# KVU OSLO- NAVET

## Inconsistencies

**Prosjekt:** KVU Oslo-Navet

**Vedlegg til:** Delrapport 4, Konseptanalyse

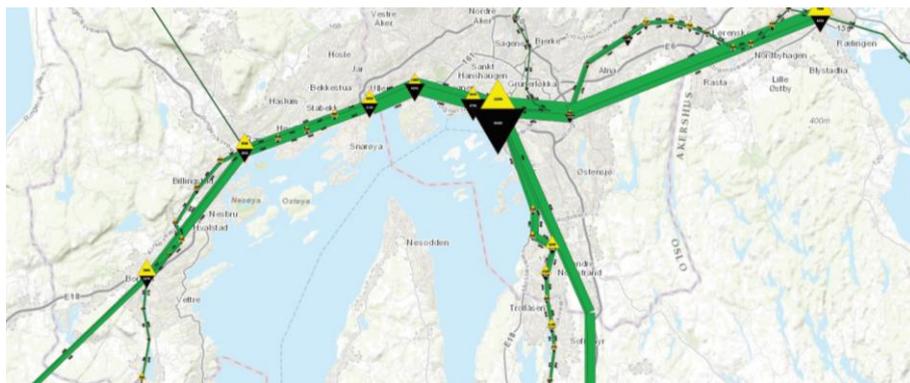
The experts are of the opinion that there is no real reason not to use the tramway network with its full capabilities also in scenario K2 and K4 where the “new catchment function” of both metro and railway appears limited. Only in K3 there appears to be a good reason for limiting tramway scope in the centre as both metro and railway offer new underground corridors with already much better catchment spread.

Making this reservation for K3, however, touches mainly on the tramway cross-link in W Thranes gate - Sannergate which is not required here due to the new railway (S-Bahn) corridor.

Other features of K1 should and could without any problem be integrated into K2-K4 scenarios, especially Sporveisgata as a vital link.

The Fredriks gate link seems to be missing in all alternatives?

K1

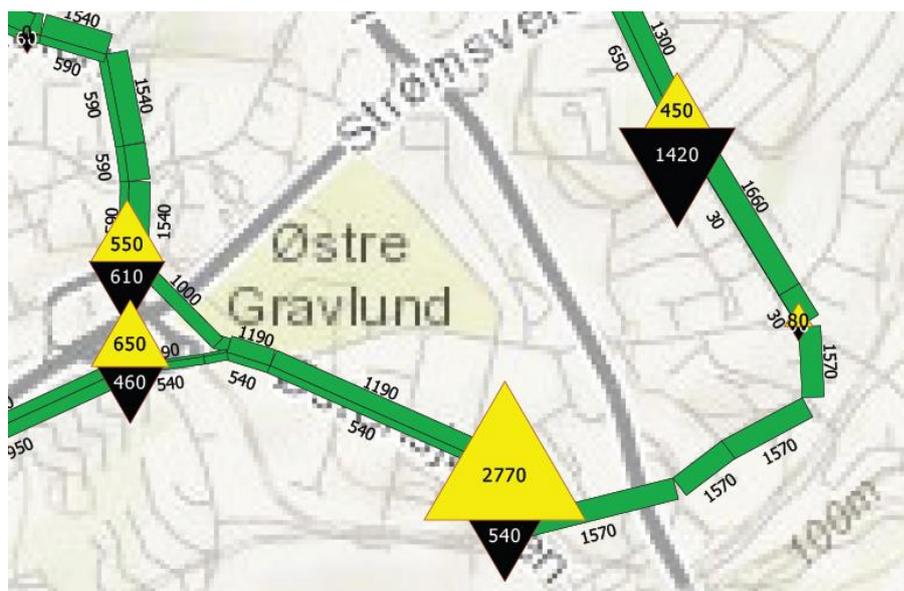
There seems to exist some coding error in the Bryn area where the plots for different scenarios show only values for one travel direction respectively only boarding passengers. The results seem also to be inconsistent between scenarios – compare K1 and K3 for 2030.

Looking at the important network function foreseen for Bryn as the major interchange node in the East of Oslo centre this can't represent a realistic modelling result?

K3

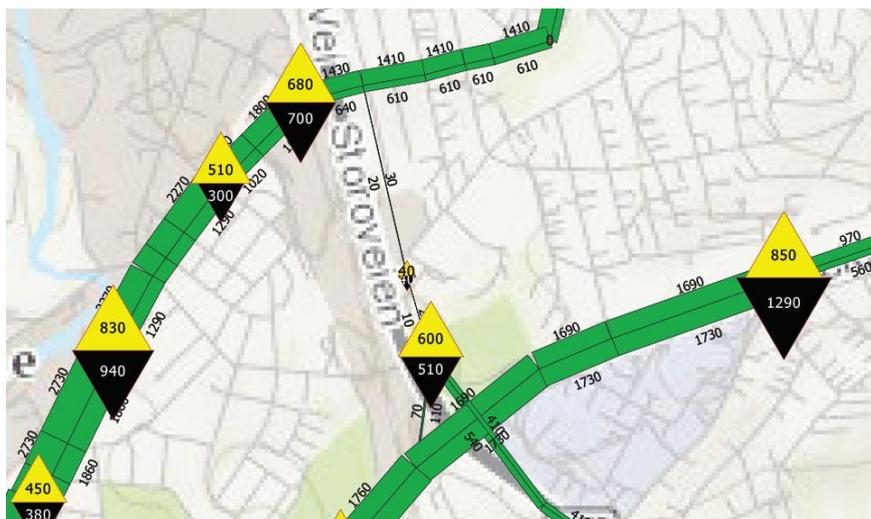
Another inconsistency seems to exist in the Storoveien link in picture below.

Values of 20/30 passengers within a 3h peak are difficult to understand when looking at the network structure in this area.

Such low numbers seem to represent tramway line 17 up to Grefsen which appears already with very low numbers in the 2010 plots.

The experts have problems to believe that these numbers represent the reality of today!

And it appears not consistent if such numbers remain more or less identical in a 2030 and 2060 scenario? Shouldn't the link of line 17 up to Grefsen station disappear completely with an extension to Tonsenhagen/Bjerke?

K3

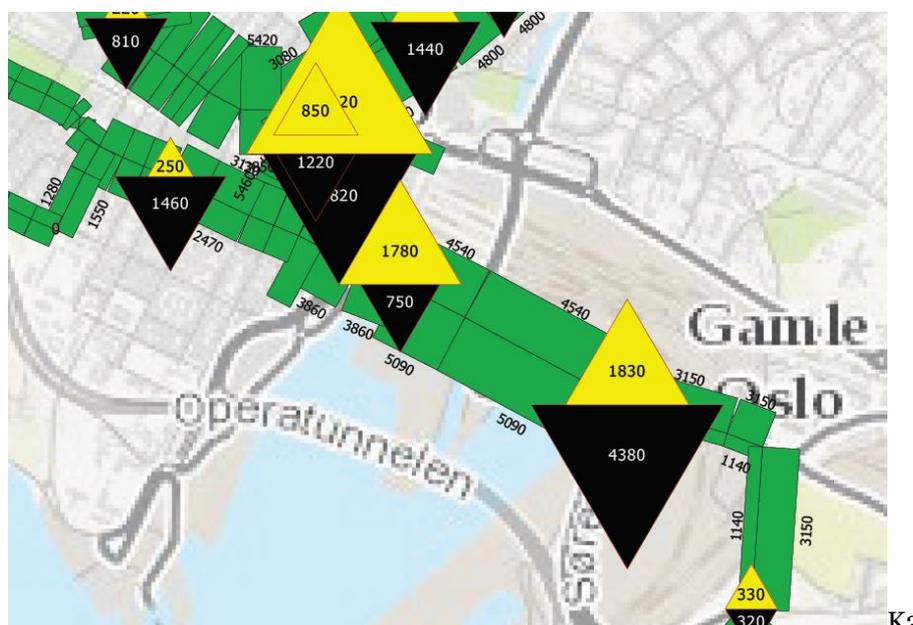
The boarding/de-boarding patterns for the tramway stops in the wider Oslo S area appear slightly inconsistent. Some stops show a significant dominance of de-boarding passengers while others show opposite characteristics? The experts acknowledge that a morning peak period may generate significantly more boarding or de-boarding passengers depending whether a stop is located in an area where traffic originates or is destined to. But it is questioned whether such patterns are realistic within a rather central area?

K3 2030

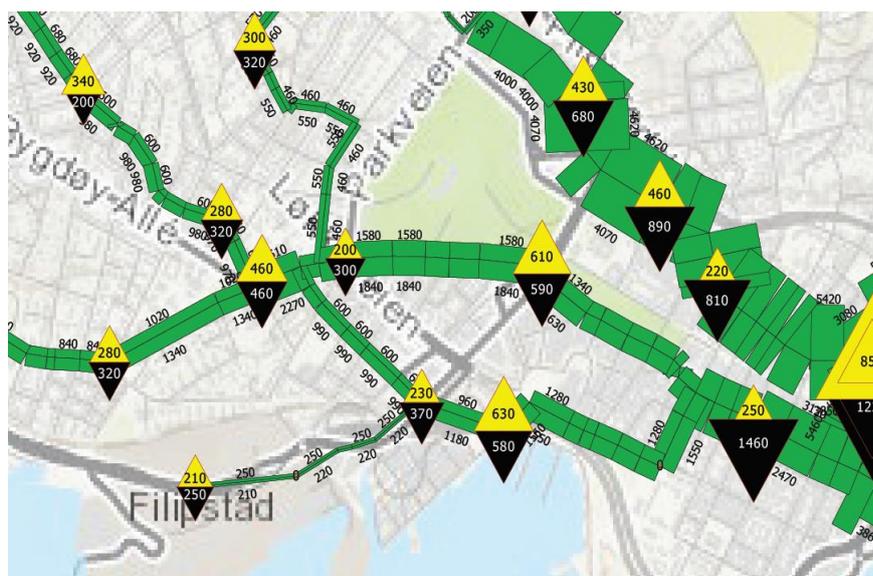
The experts have noticed with surprise the very low passenger numbers given as modelling results for the Filipstad link. These numbers justify the question whether the future function of Filipstad which is described as a “big development area” has been properly featured in the traffic model? Even more surprising that there is nearly now further increase up to the year 2060?

Figur 21: Mulig trasé for trikk gjennom Filipstad (Kilde: Statens vegvesen Region øst)

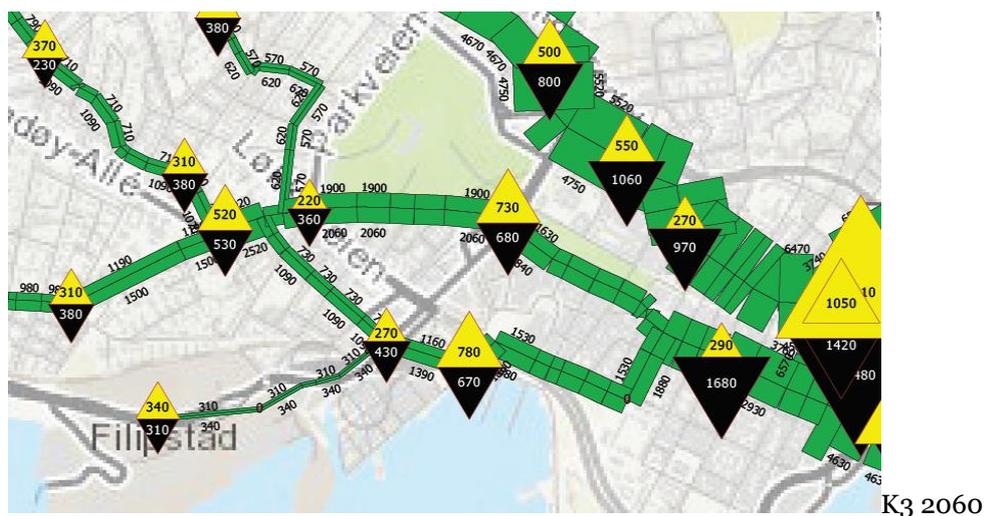
The experts have stated in chapter above that they are rather surprised about the very low patronage increase in a 30 year period from 2030 to 2060. The new tramway link into Filipstad raises, however, concerns beyond modelling reactivity. Across all scenarios the Filipstad line seems to have been assumed terminating in the Filipstad area. Other reports as eg the “Teknisk-Økonomisk Report” speak, however, of a continuation and linking to existing infrastructure, however, more as a future, long-term

perspective. Such continuation would certainly give this line more of a network function. The experts wonder why such function hasn't been integrated in the model from the beginning?

It must be stated very clearly that the patronage values resulting for Filipstad from the model are far below any threshold for justifying tramway infrastructure and such evaluation should have been taken forward in the KVVU instead of just proposing new network bits without controlling their effectivity or optimizing those after an identification of "problems". This could be seen as another example for the experts' concerns stated in the annex 1 in regard of missing "minimum demand" considerations respectively a missing "optimization phase" as mentioned in the final report.
